TECHNICAL BULLETIN

[Issue No.] FA-A-0064

[Title] Precaution for a battery error of the C Controller module

[Relevant Models] Q06CCPU-V, Q06CCPU-V-B

Figure 1. C Controller setting utility (System settings)

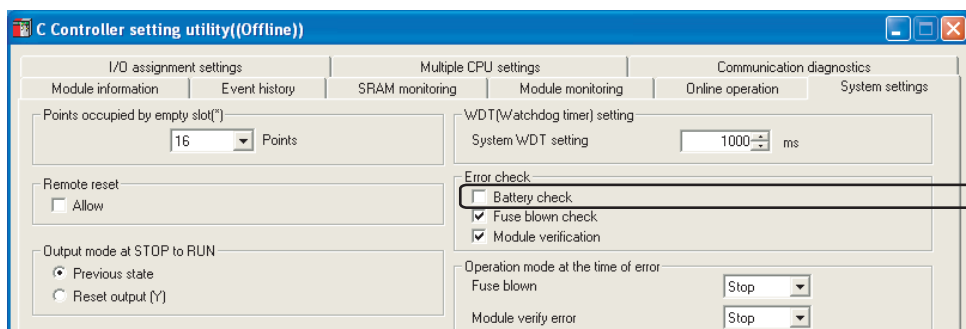
Note that no battery error will occur if the battery check is disabled in C Controller setting utility.
